Change Order

PROJECT (Name and address):	CHANGE ORDER NUMBER: 008	OWNER: ⊠
Radcliff Elementary School Renovation	DATE : July 21, 2011	ARCHITECT:
- Phase 3 1145 S. Dixie Boulevard		CONTRACTOR
Radcliff, Kentucky 40160		<u> </u>
TO CONTRACTOR (Name and address):	ARCHITECT'S PROJECT NUMBER: 1004	FIELD:
Morel Construction Co., Inc.	CONTRACT DATE: January 10, 2011	KENTUCKY DEPARTMENT OF
627 West Main Street Louisville, Kentucky 40202	CONTRACT FOR: General Construction	EDUCATION: S
THE CONTRACT IS CHANGED AS FOLLOW (Include, where applicable, any undispute	IS: ad amount attributable to previously execute	d Construction Change Directives;
discovered that the existing 6" fire protect	or new site development at the front (east) are ion piping was not located as indicated on the curb inlet, and therefore requires relocated in this area.	he site survey. The existing location of the
The original Contract Sum was The net change by previously authorized of The Contract Sum prior to this Change Or The Contract Sum will be increased by the The new Contract Sum including this Change The contract Sum including this Change The original Contract Sum including this Change The original Contract Sum was

PARTIAL SITE UTILITY PLAN - MEP

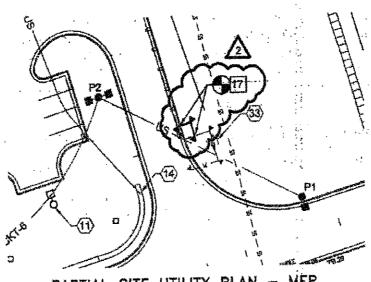
Contractor to relocate existing 6" fire protection piping as required to avoid interference with new curb inlet. Refer to the attached proposal request drawing.

17. RELOCATE EXISTING 6"FP AS REQUIRED TO AVOID INTERFERENCE WITH NEW CURB INLET.
